Subject: DM/26/0935 Discharge of planning conditions 3, 4, 10, 11 and 14 relating to planning application DM/24/2530. Premier Inn, Charles Avenue, Burgess Hill, West Sussex

Please see below my comments discharge of planning conditions 3, 4, 10, 11 and 14 relating to planning application DM/24/2530.

Most details provided are acceptable with the exception of 6063-PL-254-A which is not in line with the approved drawings.

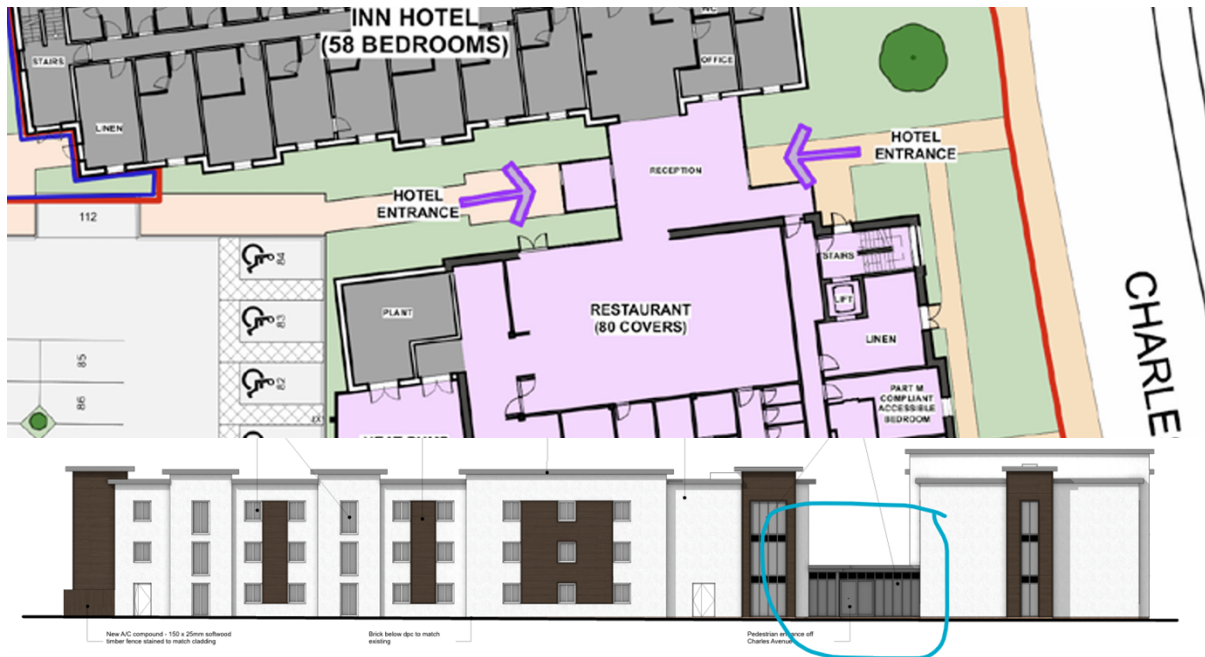
Not acceptable.

The proposed removal of the pedestrian entrance off Charles Avenue is strongly opposed. This change reduces permeability and undermines pedestrian connectivity.

Furthermore, replacing an active frontage with a curtain wall and a back-of-house style railing creates a visually inactive edge, which is detrimental to the quality, safety, and vitality of the public realm.

The proposal does not align with established urban design principles that prioritise active frontages and pedestrian-friendly environments.

The plan provided was recently granted under a non-material amendment (DM/26/0995), the justification provided was to meet building regulations and to facilitate the simplified entrance ramp.
